Report to: Greater Cambridge Partnership Executive Board 3rd October 2019

MADINGLEY ROAD CYCLE AND WALKING PROJECT

Summarised Stakeholder Feedback and Design Response for Workshops Two and Three

Madingley Road Cycle and Walking Scheme
Summarised Stakeholder Workshop 3 (23/07/2019) Comments and Design Responses/Actions

SECTION A-A

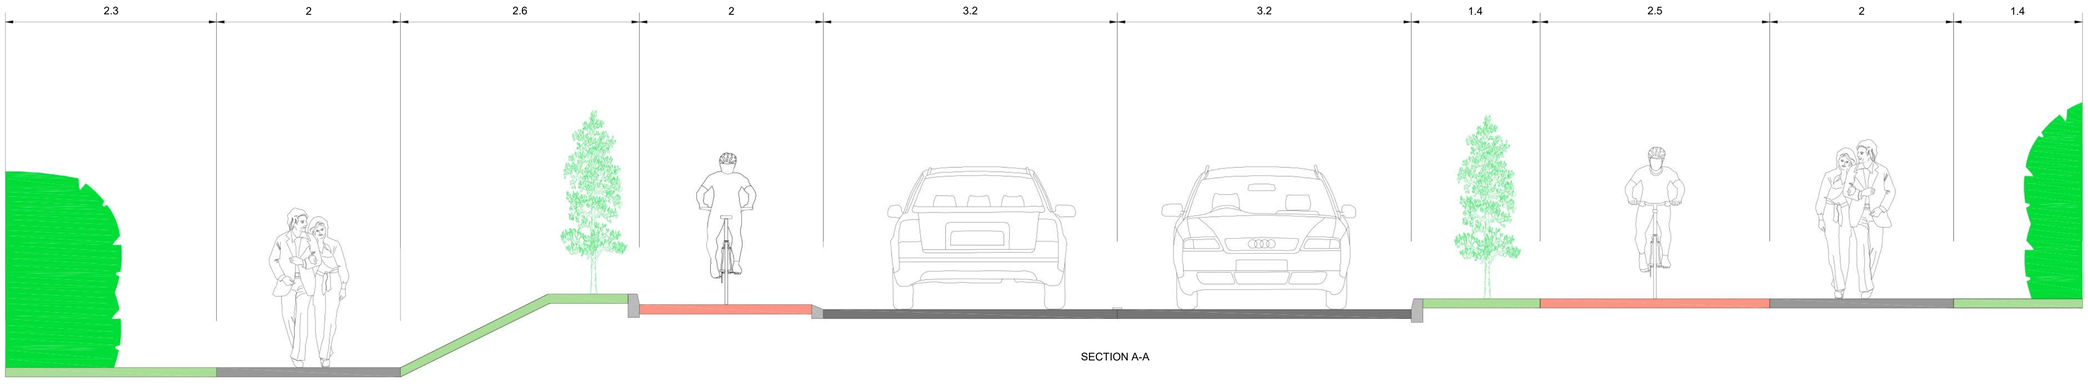
Ref	Comment	Design Response
1	Stakeholder Workshop 2 Option 2 marked as preferred option for this cross section A-A	Stakeholder Workshop 3 Layout options to be based on Option 2.
2	Question about visibility at junctions due to proposed vegetation.	Visibility will be considered at all junctions, particularly in regards to new/existing vegetation.
3	Speed limit should be reduced to 30mph throughout.	Proposals can be for 30mph with agreement.
4	A retaining wall was proposed for the level difference on Stakeholder Workshop 2 Section A-A to provide a flatter verge.	Retaining wall would not be ideal for this area and will be avoided if possible due to cost, future maintenance and potential issues for adjacent landowners and footway users.
5	Development of 34-36 Madingley Road visibility concerns highlighted.	Visibility will be considered for accesses in future design stages.
6	Stakeholder Workshop 2 Section B-B Option 4 preferred.	Option will not be used due to issues surrounding a footway within Churchill College land. Stakeholder Workshop 3 Option 2 shows ditch relocated further into Churchill College land to provide cycleway and footway facilities.

SECTION B-B

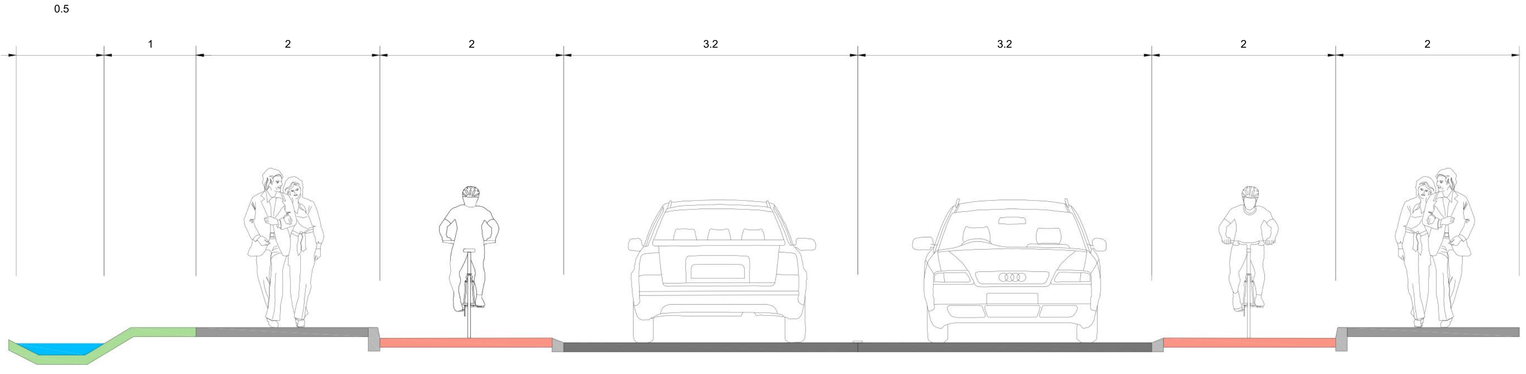
26	Comment favouring cross section B-B	1	This cross section will be proposed for the more constrained sections, with the more of the scheme to be fully segregated from the carriageway.
27	Comment not in favour of Cambridge Kerb	1	Cambridge Kerb has been seen as favourable. While a wide segregated cycleway has been proposed for a reasonable length, there may be areas where Cambridge Kerb would be more appropriate.

SECTION C-C

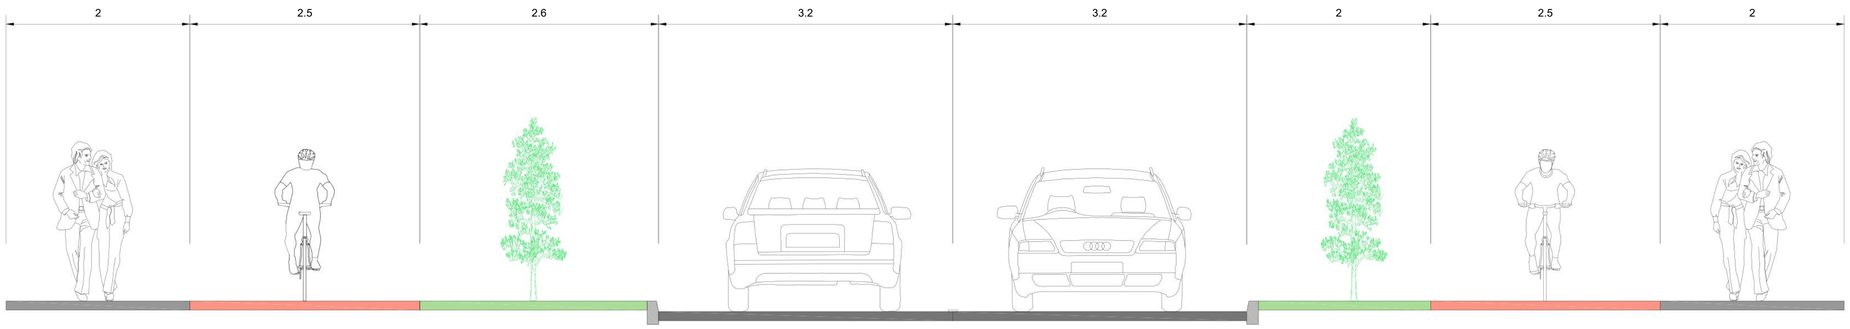
7	Keeping ditch favourable	Ditch will be kept, however Stakeholder Workshop 3 Option 2 to suggest relocation of ditch to provide cycleway and footway facilities.
8	Stakeholder Workshop 2 Section C-C Option 3 preferred	Cross section to be used in layout options. A modified cross section will be used in options where a bi-directional cycleway is not provided.
9	A lack of visibility at junctions	All junctions will be checked for visibility during future design stages. Some vegetation clearance may be necessary to facilitate visibility requirements.
10	Lack of designated crossing points. Suggested locations; Park & Ride, Lady Margeret Road, Conduit Head Road, Storey's Way, Northampton Street, Grange Road and Clerk Maxwell Road.	Additional crossing locations as suggested have been provided across the two Stakeholder Workshop 3 options. Northampton Street has not been included as this is outside of the scheme extents.

SECTION B-B

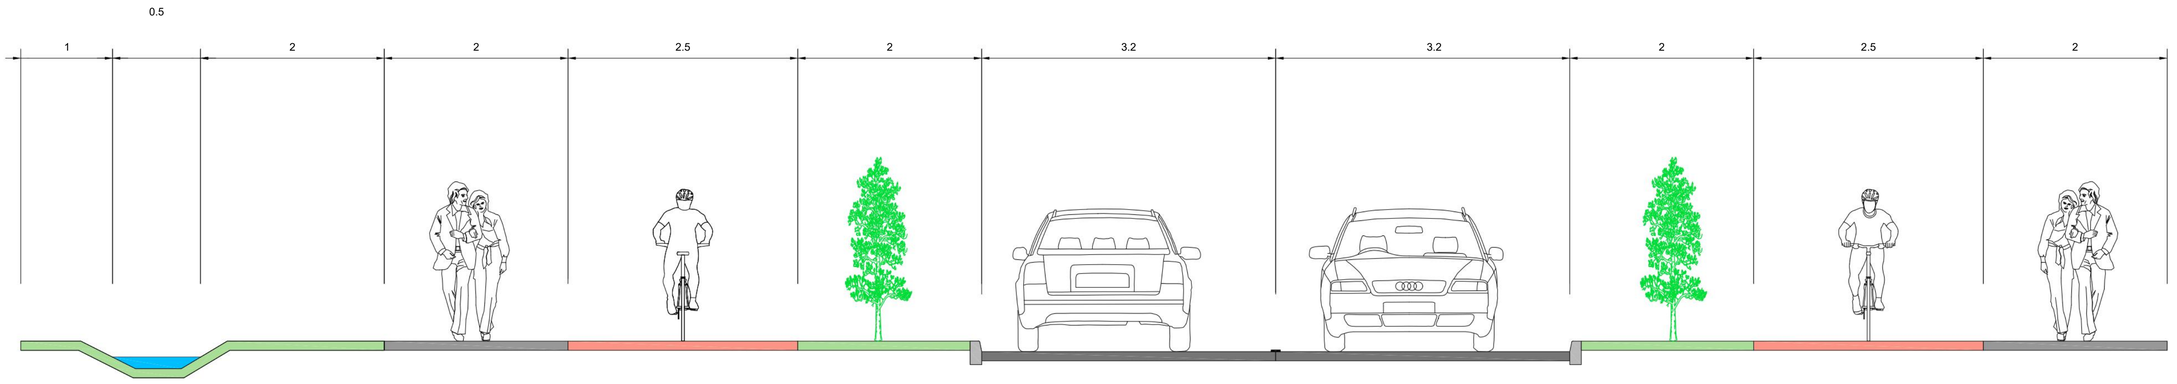
36	Comment questioning what would be planted in the verge on Section B-B.	1	Landscaping details to be confirmed in future design stages.
37	Comment favouring Option 2 at Churchill College, and Lansdowne Road due to junction layout.	1	N/A
